Review of Road Safety

Cyclist interaction within the mixed running alignment, Newcastle Light Rail

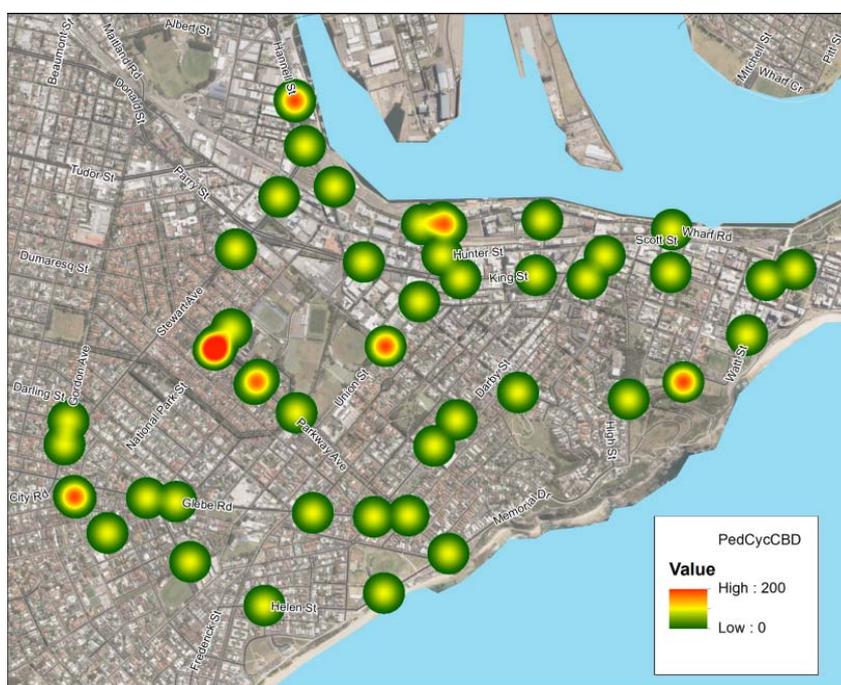
Since the fatal crash, the August 2019 road safety audit highlighted two road safety deficiencies (outlined below) have been classified as *intolerable*. In accordance with Austroads guidelines, they must be corrected. Before the fatality they had been independently rated as high-risk, based on an expected lower crash frequency.

- Scott Street westbound at Pacific Street – cyclists travelling westbound in the traffic lane are required to cross the light rail tracks at an angle that is not perpendicular
- Scott Street eastbound at Newcomen Street – cyclists travelling eastbound in the traffic lane are required to cross the light rail tracks at an angle that is not perpendicular

Following consideration of the identified 'intolerable' risks to cyclists, the chief recommendation of this report is that cyclists should be excluded from using the mixed running section. The exclusion zone should not only apply at the intersection of Scott and Pacific streets but should extend to the entire 340 metre length of the mixed running section. This outcome is supported by NSW Police who also have also raised concerns with the ability for general traffic to maintain a safe passing distance with cyclists.
